Advisory Design Panel Report For the Meeting of February 23, 2022

To: Advisory Design Panel **Date:** February 9, 2022
From: Charlotte Wain, Senior Planner - Urban Design
Subject: **Development Permit with Variances Application No. 00182 for 1030 Fort Street**

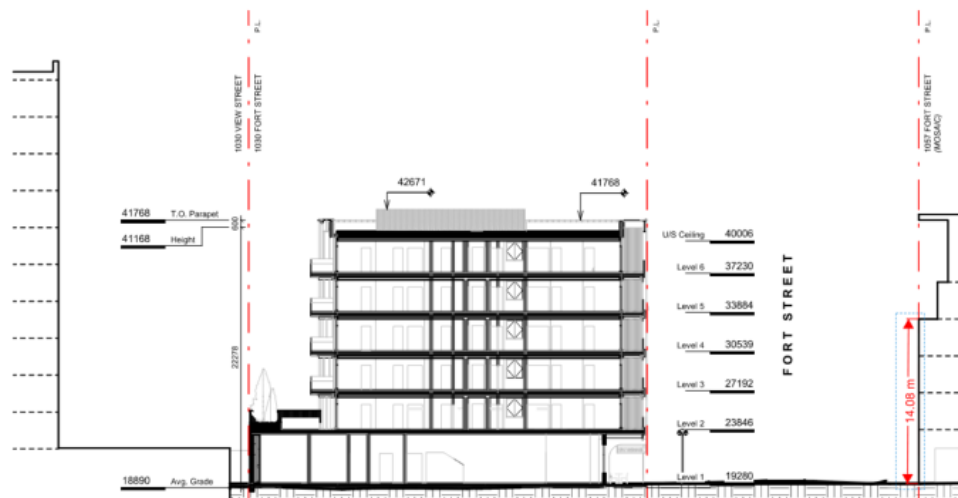
The OCP designation for this site envisions street wall heights from three to five storeys. The applicant proposes a six-storey street wall. One of the primary objectives of this Development Permit Area (DPA) is to achieve cohesive and high-quality architecture and urban design that is responsive to its historic context. The corridor consists of predominantly lower-scale buildings with highly articulated retail frontages. Where taller buildings have been introduced, upper-storey setbacks have generally been provided in order to provide buildings that do not overwhelm the right-of-way and are respectful of the public realm.

The Guidelines state that particular attention should be given to the context in which the proposed building is being introduced, with Fort Street being defined as a “narrow” street in which a maximum primary street wall height of 15 m is recommended (the proposal is 22m). In terms of the immediate context, the six-storey apartment building (The Mosaic) across Fort Street represents a street wall that conforms with the current guidelines and the relationship between this existing building and the proposal is represented on a cross-section in the architectural plans (drawing A500) illustrated below.

Street setbacks are defined in DCAP to reduce building bulk of upper storeys, to minimize the effects of shading and wind vortices, to maintain views to the open sky, and to avoid the visual presence of bulky upper building mass. In this instance, the lower scale building form, the north-south orientation of the building and the highly articulated façade all mitigate the infringement impact and help achieve the objectives described above through other design responses.

It is also relevant to note that whilst the proposal exceeds the maximum height for street walls in the existing guidelines by approximately 7m, it does conform to the emerging (although not yet adopted) DCAP guidelines. In the new Guidelines, maximum street wall heights only apply to tall buildings, which are defined as any building over 23m in height. Through the DCAP update process, the front setback plane regulations are proposed to be removed from the CBD-2 Zone, which would eliminate the variance identified in the data table earlier. The intent of allowing six storey street walls is to encourage a lower-scale perimeter block form across the downtown core provided this does not negatively impact the perception of pedestrian comfort, safety and vitality within public open spaces. Upper storey setbacks are noted as a potential design intervention to encourage sunlight access and a comfortable street enclosure; however, this is less relevant in this case since the shading impacts of the proposed building predominantly exist to the rear (north).
